# Conceptual Review Agenda

Schedule for 12/08/14 to 12/08/14

**Re:** 6250 S College - Road and Fence

**Re:** 1912 Laporte - Solar Farm

SITE PLAN  
(1MW OPTION)

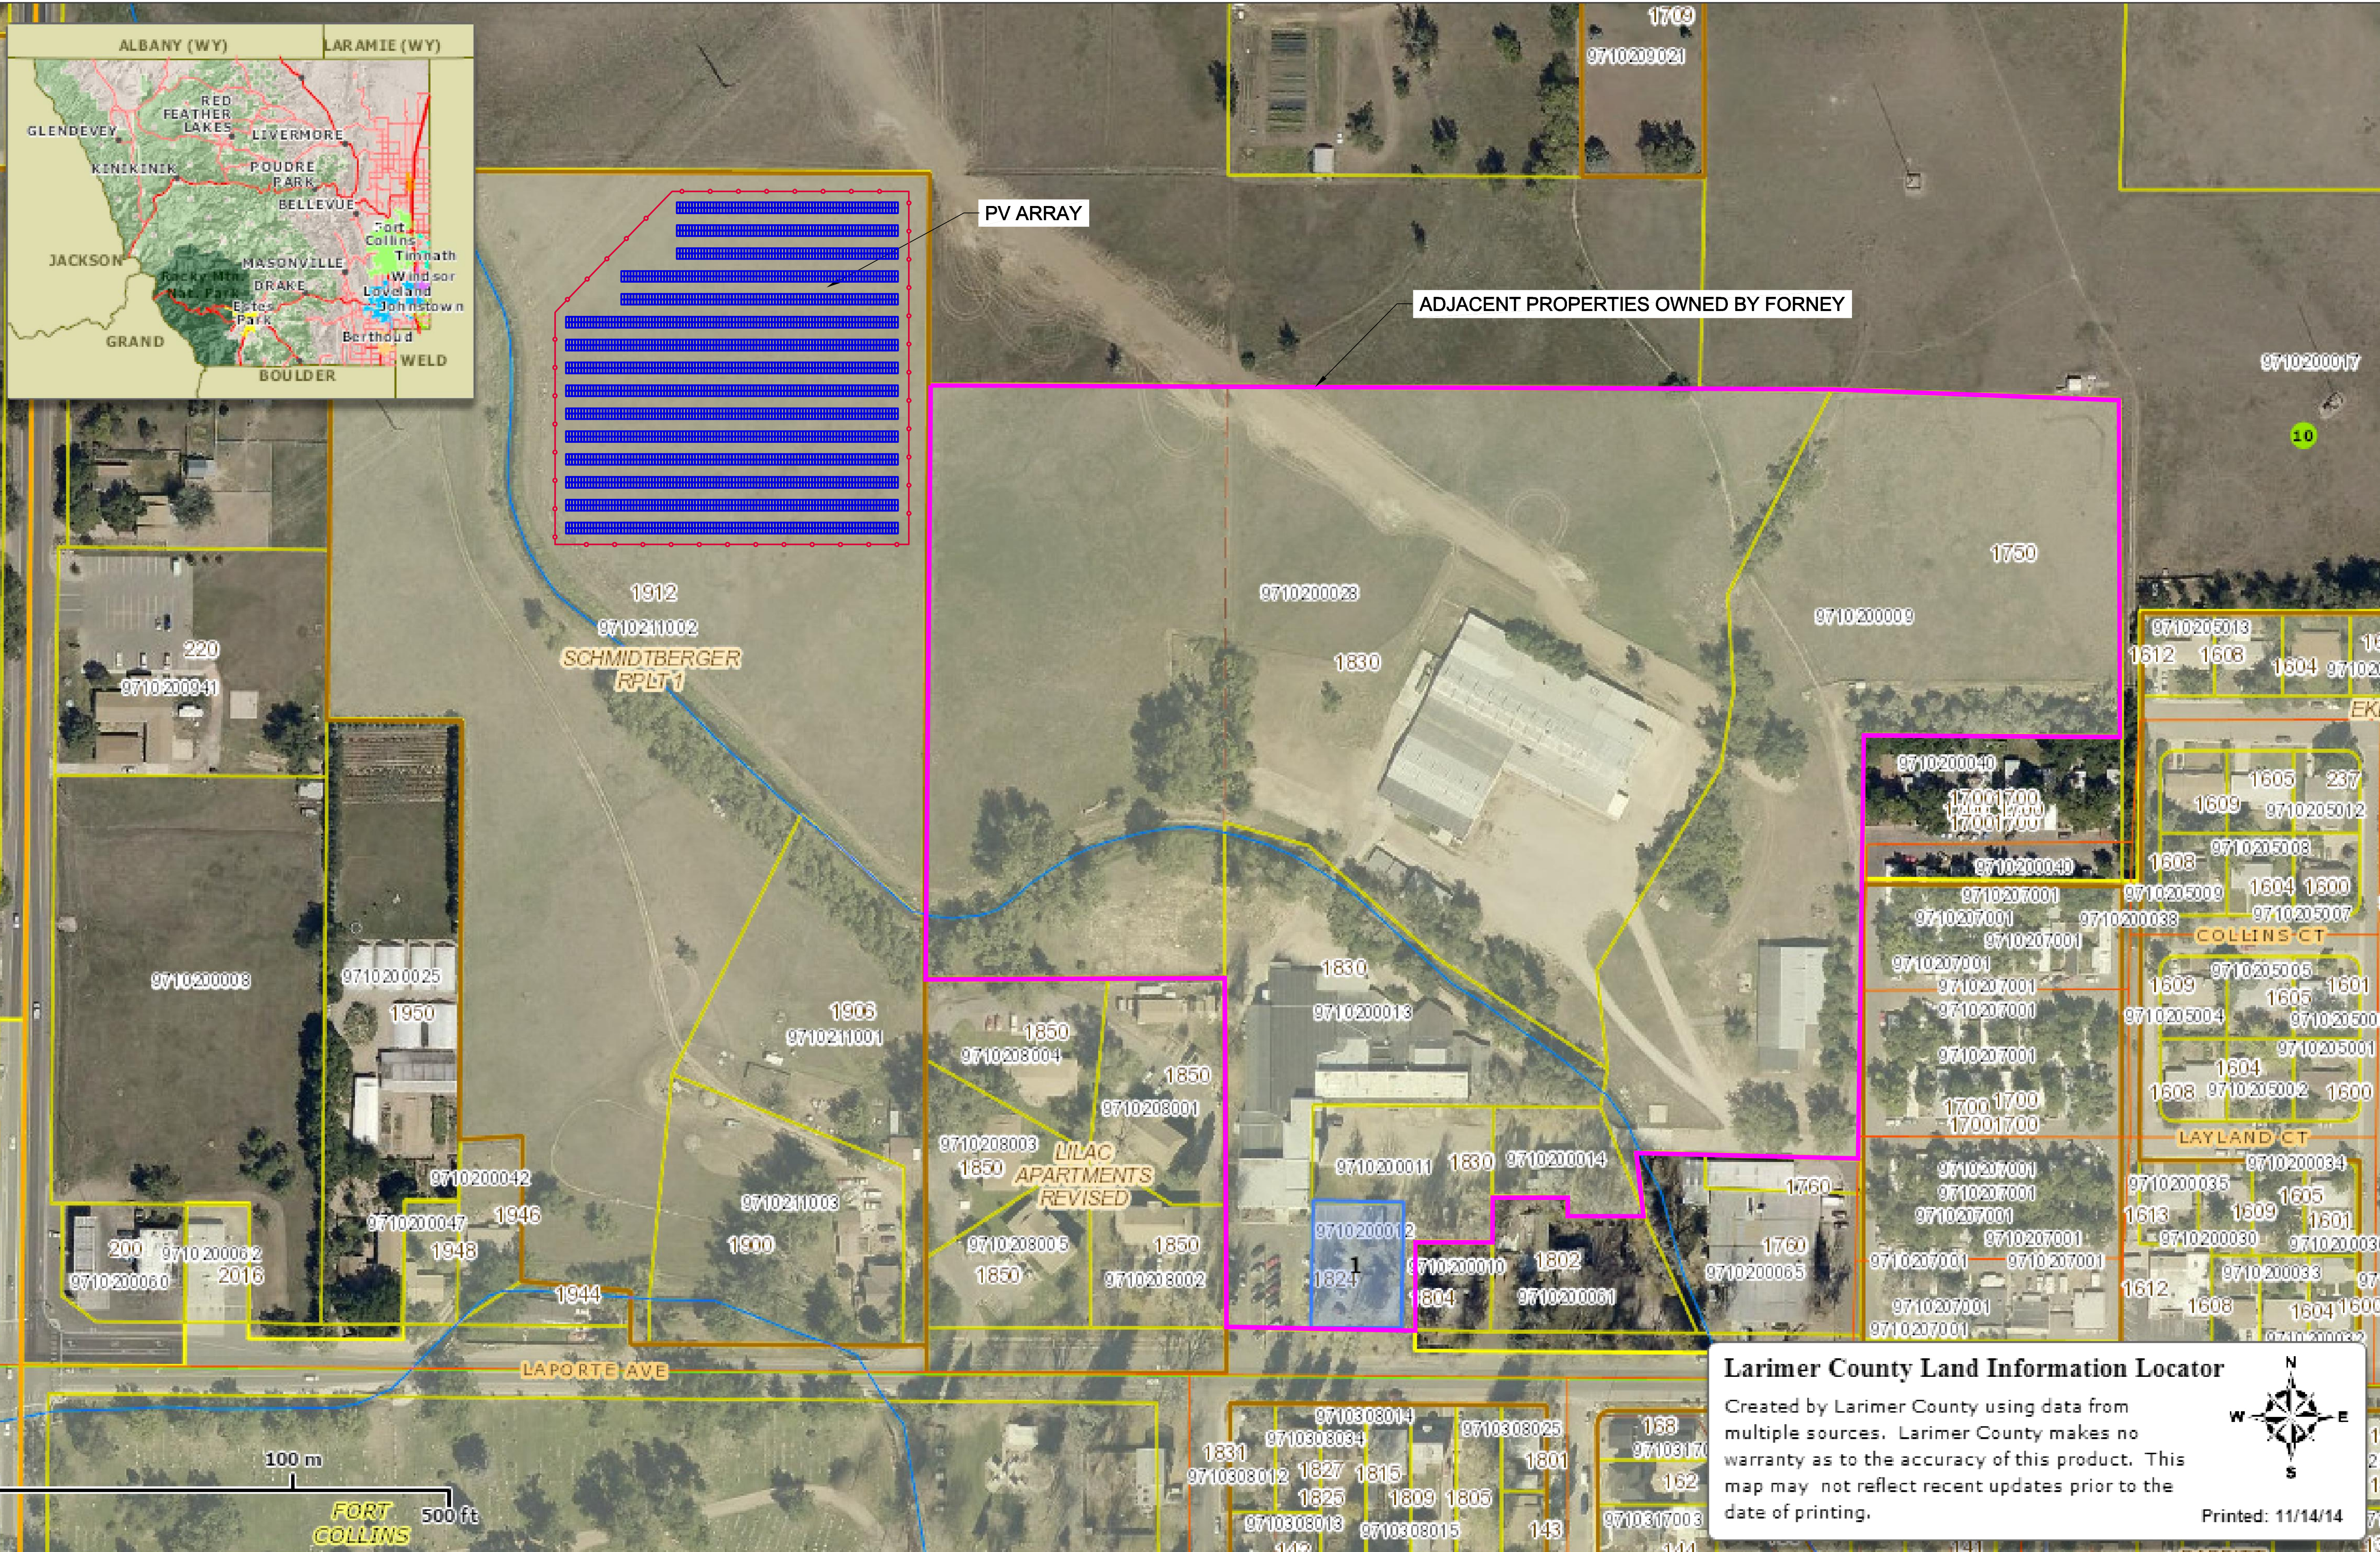
1. The anticipated change in traffic volume is not expected to rise to the threshold of needing a TIS. Based on section 4.2.3.D of LCUASS, the Traffic Impact Study requirement can be waived.
2. Where will the access road for the farm be located?

11. How will access to the back area where the solar panels are shown going to occur? If access will be across the ditch(es). You will need to work with the ditch companies, they will need to sign the plans, and you will need to provide the City with copies of any ditch crossing agreements that are entered into. If access is across other property then you will need to obtain access easements and provide a copy of the recorded easement to show that you have permission to construct an across the property and use it. If you are looking at obtaining an easement for access or utilities across City property then you will need to work with the City's Real Estate Services department.

1. The location of inverters or other equipment should be designed to be out of public view (interior to the array), or to utilize a combination of walls, fences and landscaping to screen or mitigate visual impacts.
2. Depending on the ultimate configuration and location of the panels, landscaping may be required to assist in screening the solar energy system from nearby residences or the public right-of-way.
3. The solar energy system must be fenced. The fencing should be a minimum of 5' tall but no more than 7' tall and the fencing design should be complementary to the surrounding context to the area.
